Thank you for fielding all these emails regarding the Planning Application submitted by Maura Development Group for 100 Plains Rd East.

## Comment on Development Proposal – 100 Plains Rd E, Burlington

Re: Planning Application 505-07/25 & 520-09/25

Figure 3: Development concept at 53-71 Plains Rd E & 1025 Cooke Blvd (as presented to OLT)

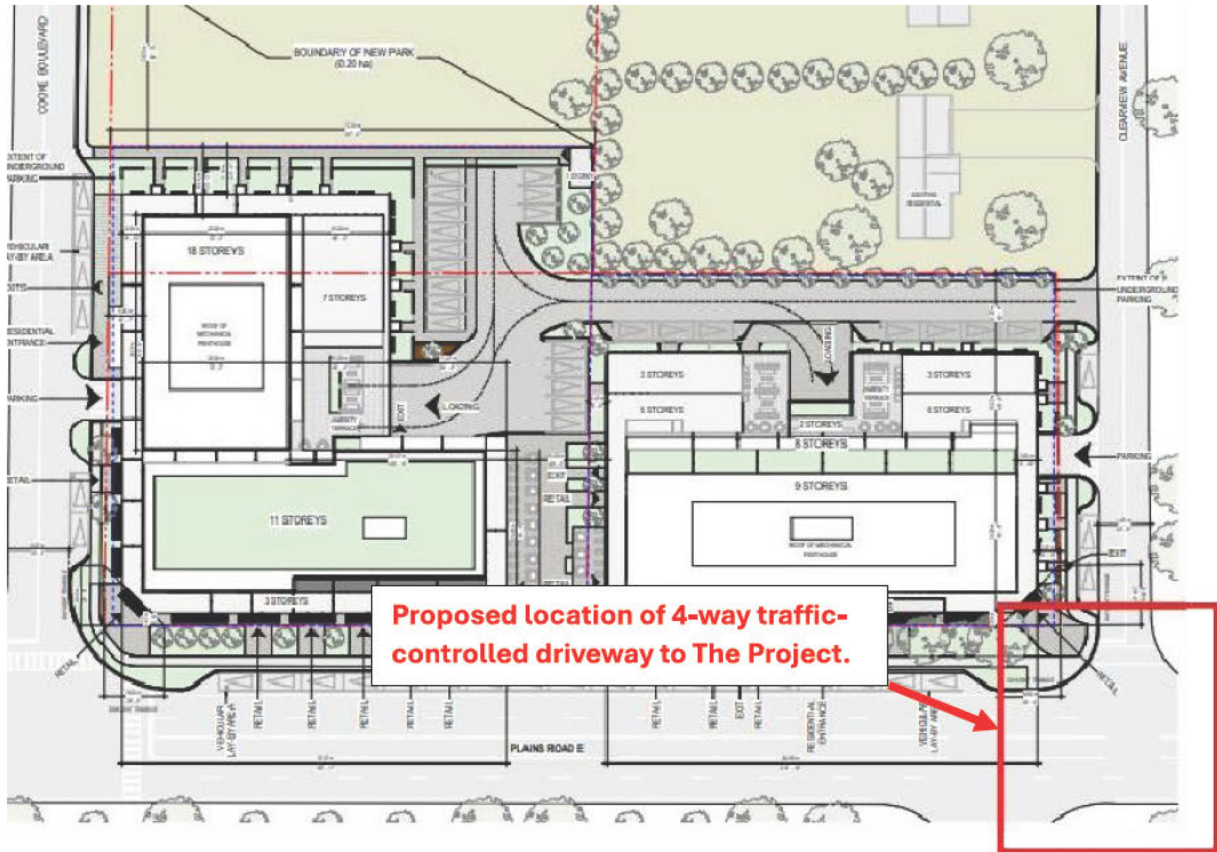
- The only driveway access to The Project should be via a 4-way controlled traffic light at the intersection of Clearview Ave and Plains Rd E. This access point aligns with west end of the The Project site and the main access point on the development at 53-71 Plains Rd. E, 1025 Cooke Blvd (Figure 3).

Figure 4: The Project is among the furthest properties from the "high peak" in the MTSA and is embedded within an existing low-rise residential neighbourhood

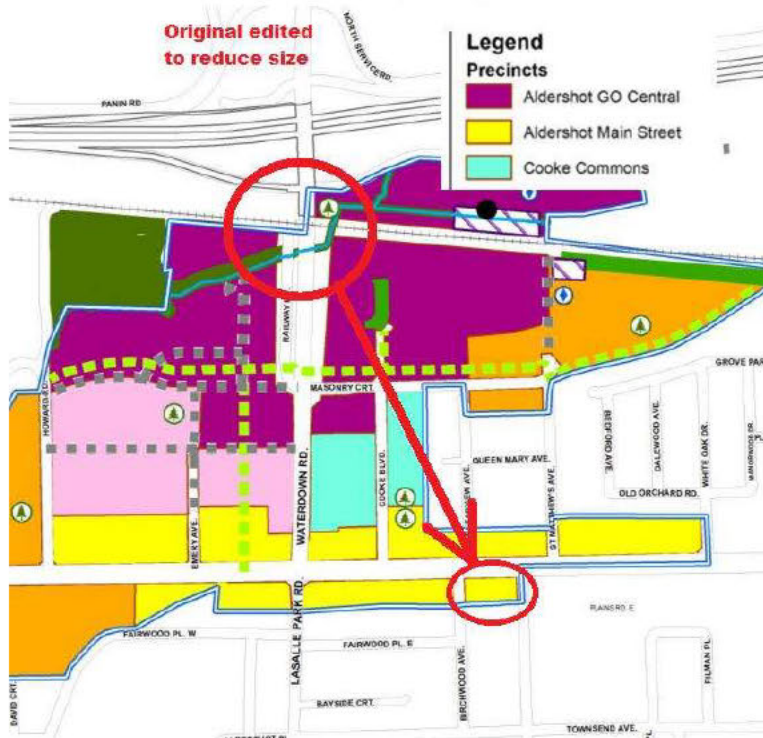
- The Project is among the furthest properties from the “height peak” or highest density area of the Aldershot MTSA, and among the closest properties to existing residential (Figure 4). Given the approved development projects and target density near the Aldershot GO, there is not a reasonable need for maximum density on land adjacent to existing residential.
- The Project should have density closer to the minimum thresholds given the more intense density that will occur in other parts of the Aldershot MTSA – namely, Aldershot Go Central, Cooke Commons and Emery Commons.

Figure 3.1

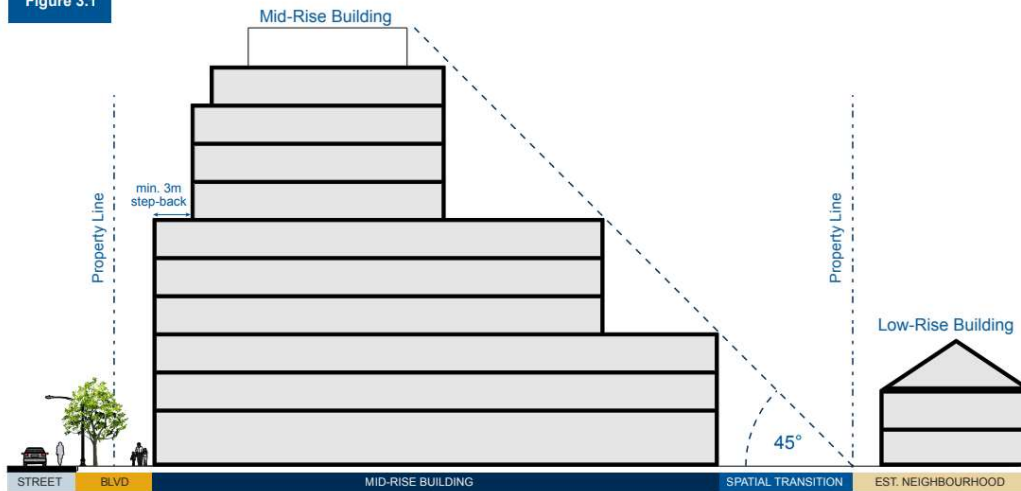
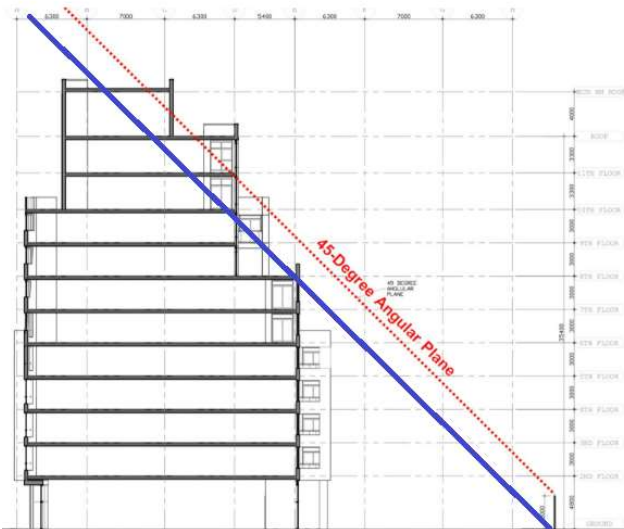
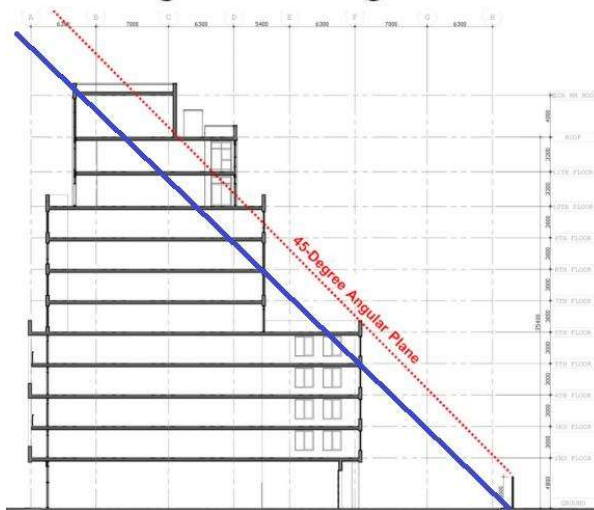
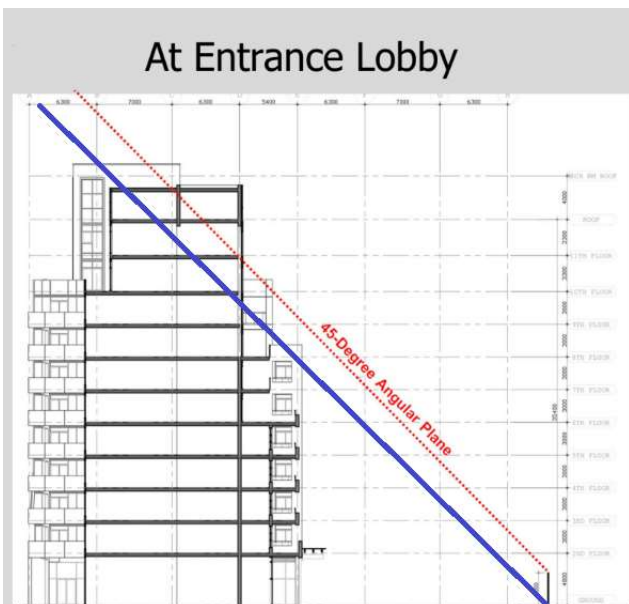
In the October 30<sup>th</sup> presentation the developer attempted to show appropriate massing using a 45-degree Angular Plane Diagram. Angular Plane Diagrams for Glenwood and Birchwood were not provided, however, they should be as the Proposal is embedded in the neighborhood on three streets and should be transitioning into the neighborhood in many directions. The Proposal extends down Glenwood and Birchwood. The houses on those streets are part of the existing low-rise residential neighborhood and deserve to be treated respectfully.

Figure 3.1 from the *Built Form Transitions* section of the Guide is reproduced below. That section also includes instructions for drawing a 45-degree Angular Plane.

The issue most immediately apparent is that the angular plane has not been drawn from "the lowest grade elevation along the shared property line". Roughly redrawn, updated angular plane diagrams are provided below. Large sections of the Proposal fall outside the angular plane. Also note that Glenwood slopes away from Plains Road (it is not a flat line as shown in presentation) so the line would start even lower than it appears in the diagram, and additional sections of the Proposal would fall outside the plane.

Conclusion: The massing is inappropriate. The Proposal fails to appropriately transition to the existing low-rise residential neighborhood. It does not meet the requirements of the MTSA, PRVV or PPS.
